Hanford Single-Shell Tank Leak Causes and Locations - 241-B Farm

Washington River Protection Solutions

Abstract: This document identifies 241-B Tank Farm (B Farm) leak cause and locations for the 100 series leaking tank (241-B-107) identified in RPP-RPT-49089, Hanford B-Farm Leak Inventory Assessments Report. This document satisfies the B Farm portion of the target (T04) in the Hanford Federal Facility Agreement and Consent Order milestone M-045-91F.

Figure 3-2. B Farm Construction Photograph, September 25, 1944 (P6145 N1600681)

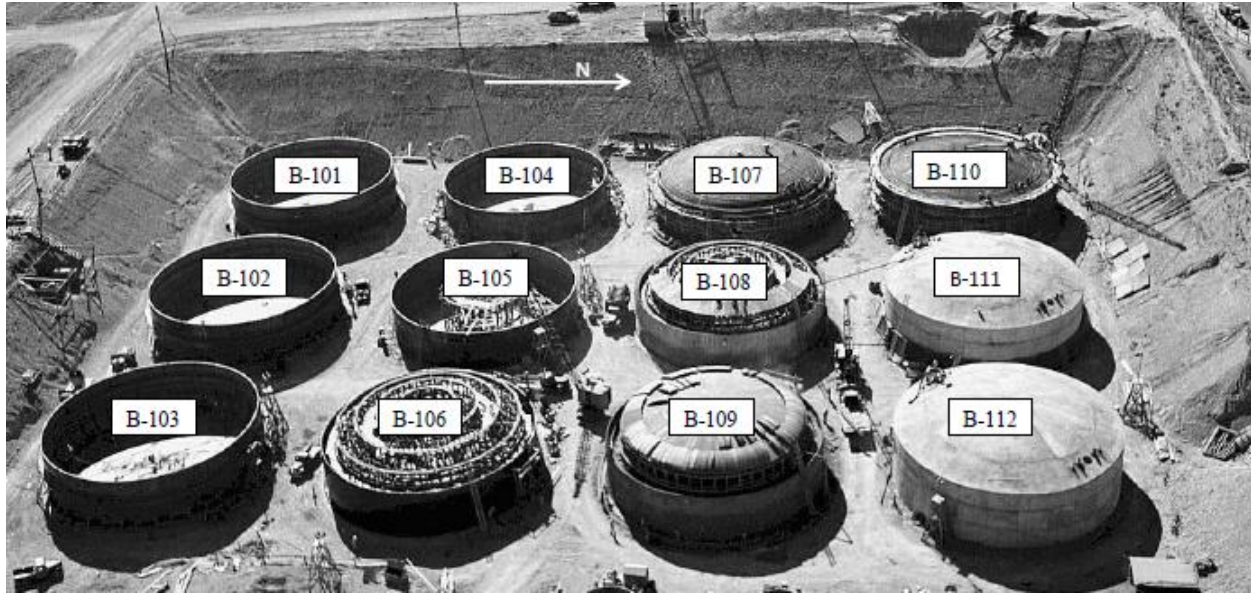
2. Pg. 3-2, Fig. 3-2. The photo caption should state that the photo is looking south, as there isn't a map showing all tanks in B Farm. Please add.

Response: A north arrow has been added to the photo to be consistent with previous tank farm segments.

Figure 4-14. Tank B-107 Possible Leak Location (1965-1973)
 Tank inner ring is steel liner; outer ring is outer edge of tank footing

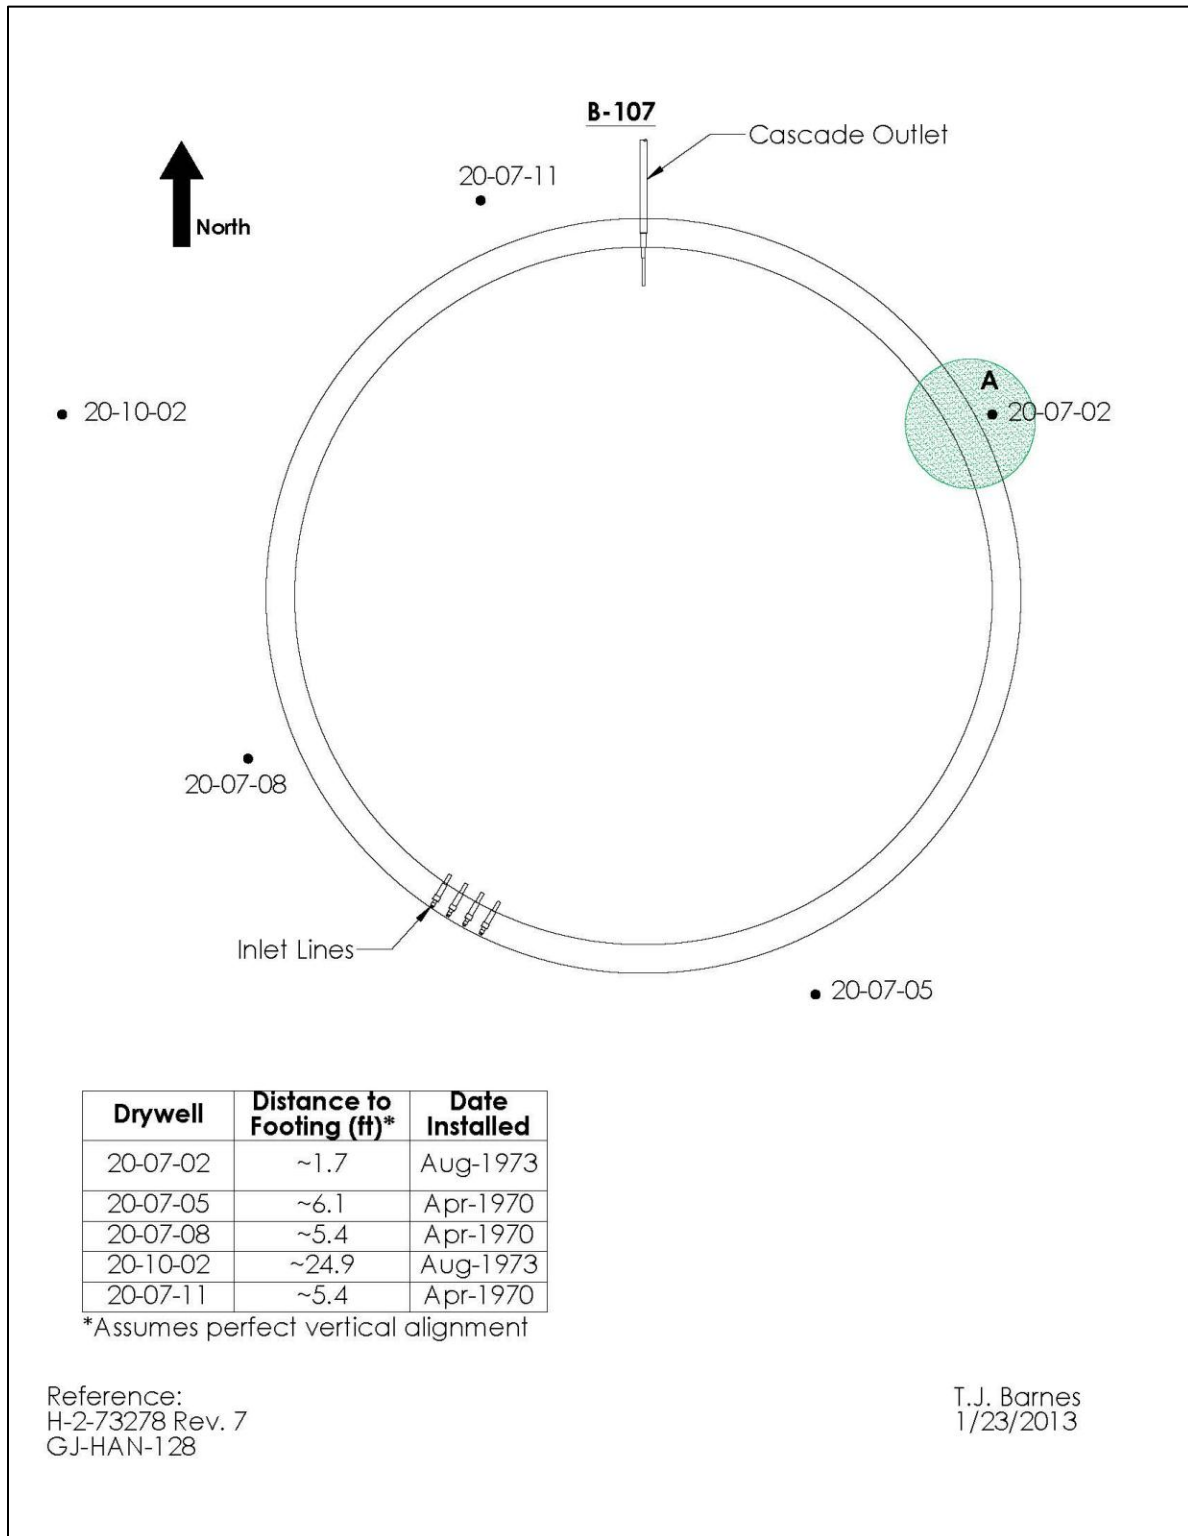
12. Pg. 4-23, Fig 4-14. This diagram shows the location of inlet lines and the cascade line, neither of which are real close to 20-07-02. The SGLS log clearly shows tank waste in this drywell at or close to the tank bottom. Even though the tank was overfilled, a release point somewhere in this vicinity with egress close to the tank bottom is suggested. Are there other possible sources for this signature? If not, then B-107 must have released waste. Please correct.

Response: Agree, see Section 4.5.1.6 fourth paragraph also Section 4.6.1 and conclusions Section 4.8.
